**CITY PLAN COMMISSION****THURSDAY, MARCH 23, 2023****FILE NUMBER:** S223-090**CHIEF PLANNER:** Mohammad H. Bordbar**LOCATION:** Singleton Boulevard, between Borger Street and Crossman Avenue**DATE FILED:** February 23, 2023**ZONING:** CR**CITY COUNCIL DISTRICT:** 6 **SIZE OF REQUEST:** 0.967-acres**MAPSCO:** 44P**APPLICANT/OWNER:** FWLB Singleton, LP

**REQUEST:** An application to replat a 0.967-acre tract of land containing all of lots 1 through 6 in City Block 2/7108 to create one lot on property located on Singleton Boulevard, between Borger Street and Crossman Avenue.

**PRELIMINARY PLAT**  
67 ACRES / 42,118 SQUARE FEET

LOT 1-4, BLOCK 2/7108  
SINGLETON HELLO CARWASH ADDITION  
A REPLAT OF LOTS 1-6, BLOCK 2/7108, EDGEFIELD ADDITION

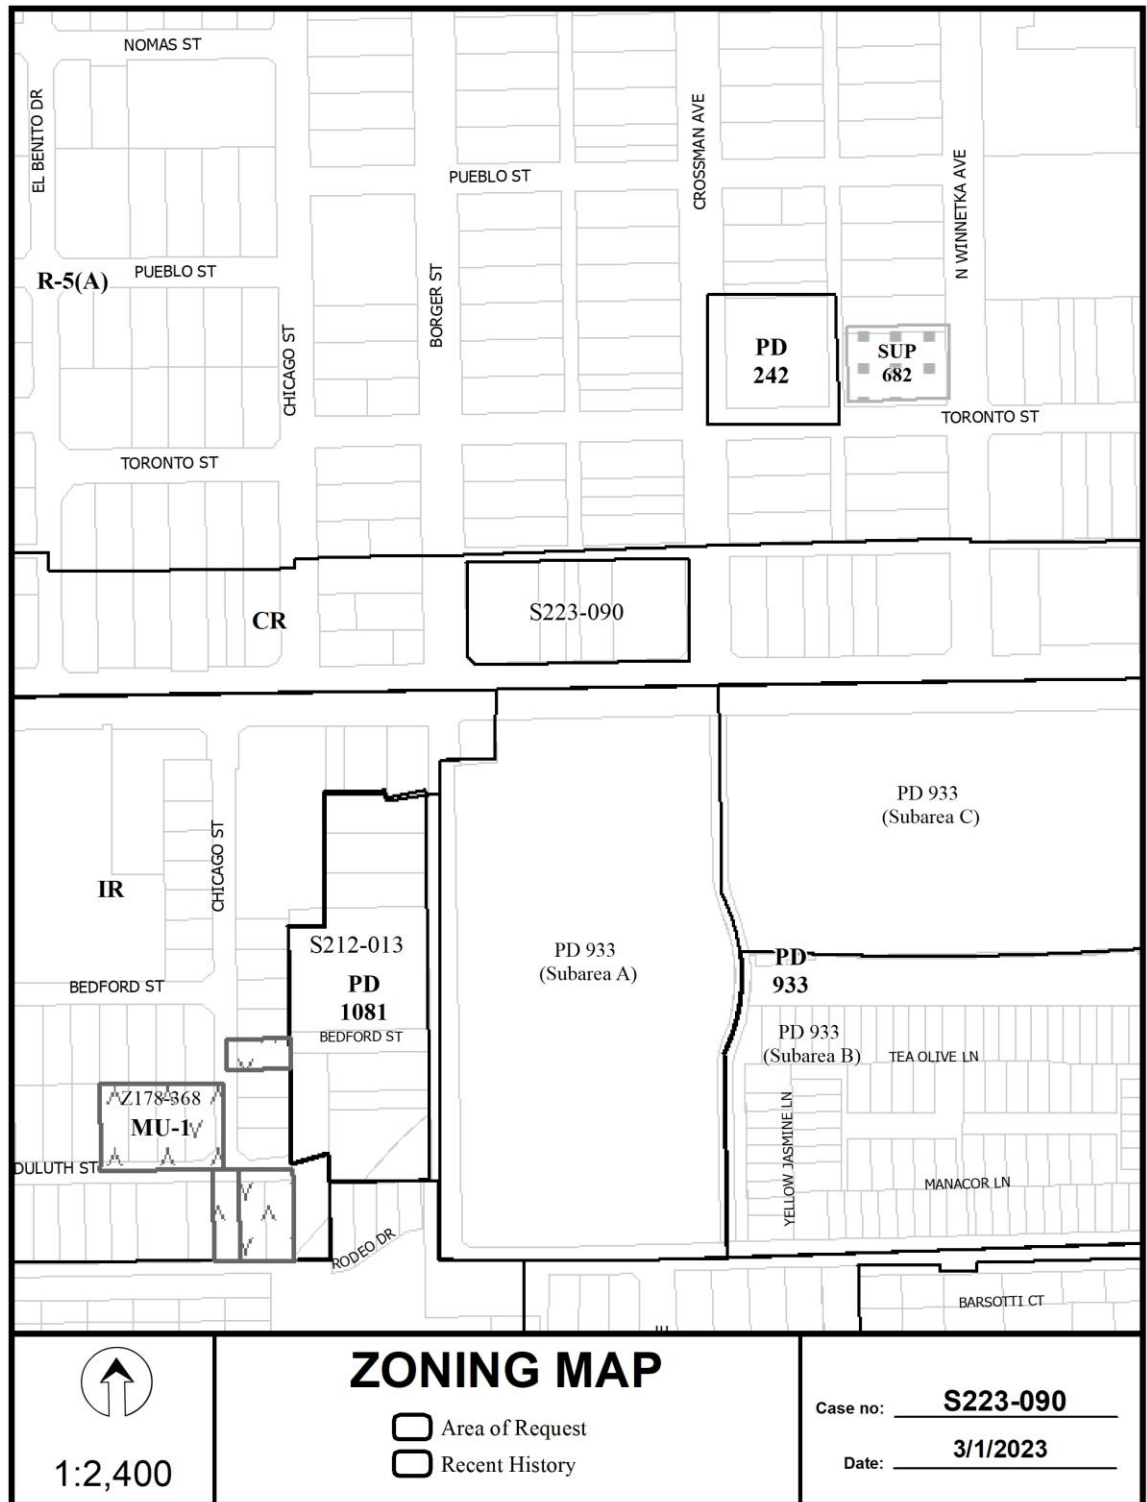
15. On the final plat, dedicate 50-feet of right-of-way (via fee simple) from the established center line of Singleton Boulevard. *Section 51A 8.602(c)*

16. On the final plat, dedicate a minimum 10-foot by 10-foot corner clip (via fee simple or street easement) at the intersection of Singleton Boulevard and Crossman Avenue. *Section 51A 8.602(d)(1)*

17. On the final plat, dedicate a 15-foot by 15-foot Alley Sight Easement at the intersection of Borger Street and the alley. *Section 51A-8.602(e)*
18. On the final plat, dedicate a 15-foot by 15-foot Alley Sight Easement at the intersection of Crossman Avenue and the alley. *Section 51A-8.602(e)*

20. Prior to final plat, submit a completed final plat checklist and all supporting documents.
21. On the final plat, show recording information on all existing easements within 150 feet of the property.
22. On the final plat, show all additions or tracts of land within 150 feet of the property with recording information. Platting Guidelines.

26. On the final plat, add a label for (F.K.A. Patrick Street) to Borger Street south of Singleton Boulevard. Section 51A-8.403(a)(1)(A)(xii)
27. On the final plat, identify the property as Lot 1A in City Block 2/7108. Ordinance 1A, Page 131 pages 131-148, Section 2 (passed August 13, 1872).
